Federal Recall Information

14KWC

IMMI seatbelt buckles may hinder egress.

3/31/2014

IMMI L9 Buckle

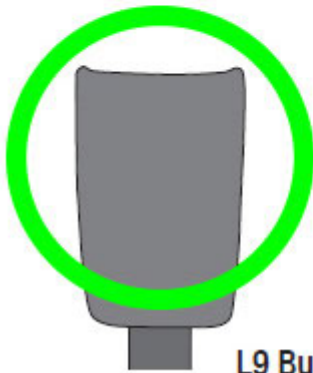
- 1)  Verify that you have an IMMI buckle by looking for the IMMI logo on the back housing. If not, **DO NOT PROCEED**.

L9 Buckle

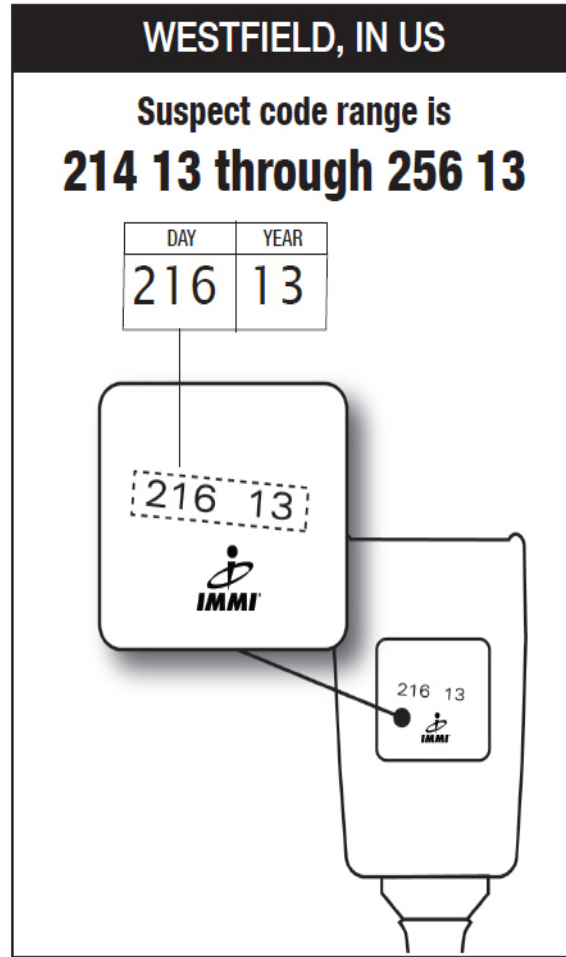
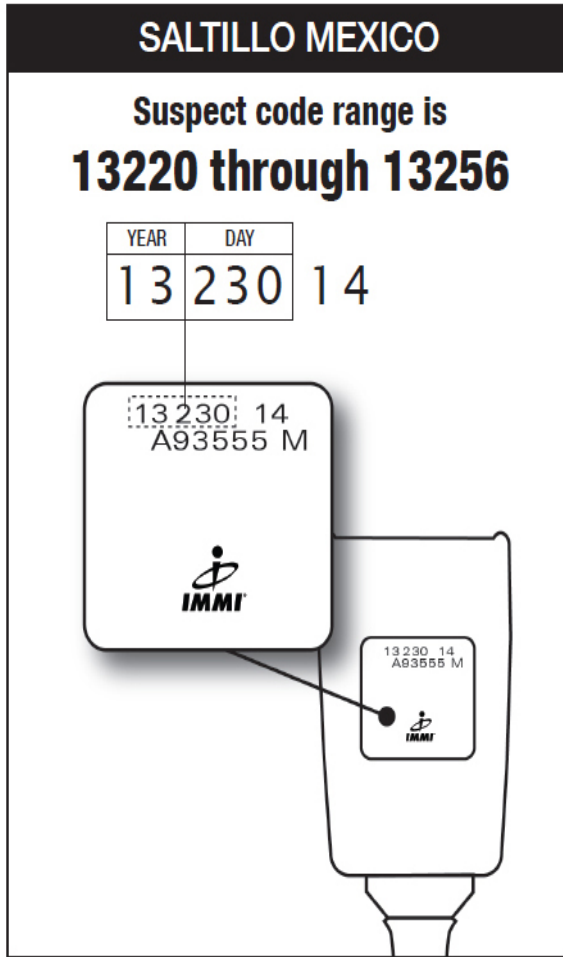
- 2) Verify you have an IMMI L9 buckle. If not, **DO NOT PROCEED**.

- 3) Verify date code is within suspect date code range. If not, **DO NOT PROCEED**.

- 4) If your buckle code is within either of the ranges above, replace your buckle with the substitute buckle. If you code does **NOT** fall within either range, you do **NOT** need to replace your buckle.
- 5) Reuse the existing bolt to install the replacement buckle. Do **NOT** apply thread locking compound when reinstalling the bolt. Torque the fastener to 35-50 lb-ft (47-68 Nm).
- 6) Destroy and dispose of all buckles verified to be within the specified suspect date code range.
